SERVICE BULLETIN

ENGINE - FUEL AND CONTROL - FUEL AND CONTROL - INCORPORATE REVISED EBU HARNESS CLIPPING
REQUIREMENTS AT CP5671 AND CP1097 - CATEGORY CODE 4 - MOD.ENG-73-0006

V2500-ENG-73-0006

View showing clipping point 5671 - Before alteration
Fig.1

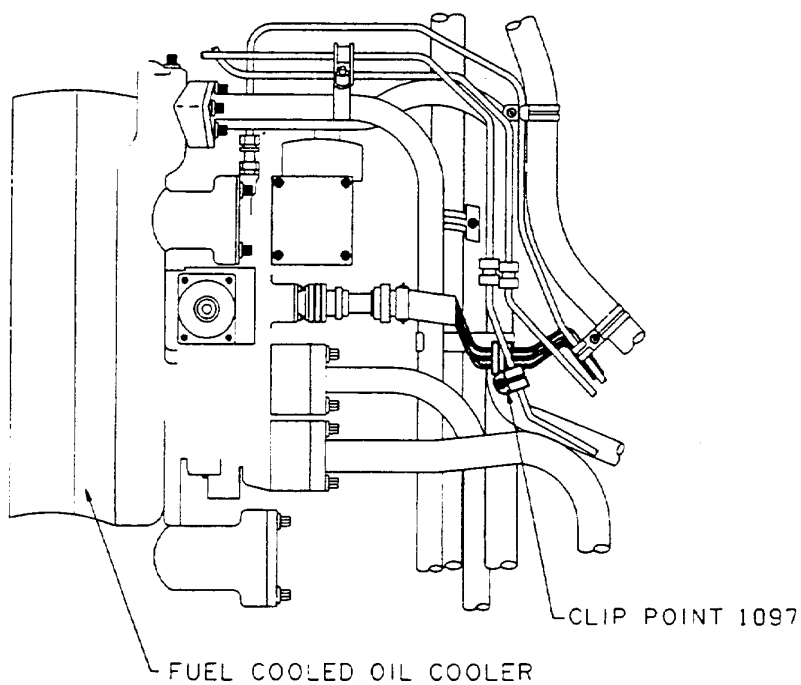
It has been found that the Low Tension (LT) harness may have insufficient clearance with an oil tube in the vicinity of the diverter valve and that the igniter/EBU harness could foul a servo fuel tube between clip points 5654 and 5671.

- (a) The LT harness is supported by a new clipping point, No.1097, and the igniter/EBU harness is moved by the addition of a 10 mm. spacer at clipping point No.5671. The position of the tube clip located at clipping point 5671 is also turned 180 degrees.

- (A) Additional
- (B) Retain for spares for other applications
- (C) New part currently available for sale
- (S1) New parts coded (S1) are to be installed as a complete set at clipping point No.1097
- (S2) New parts coded (S2) replace old parts coded(S2) as a complete set at clipping point 5671

View showing clipping points - Before and after alteration
Fig.3

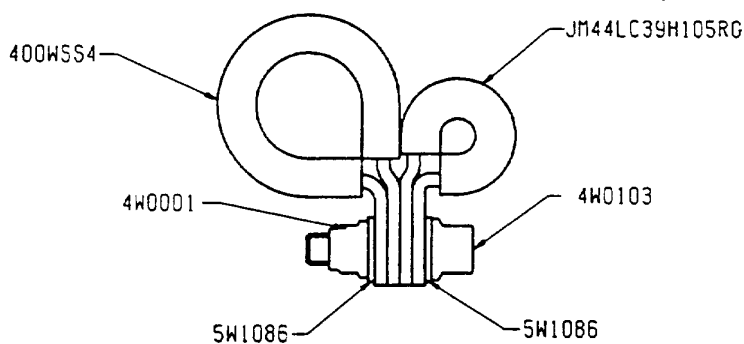
- (1) The new clipping arrangements introduced by this Service Bulletin are additional. Assemble parts as shown in fig.3 in accordance with approved procedures, Engine Manual, 72-00-32 and 72-00-40, Installation.
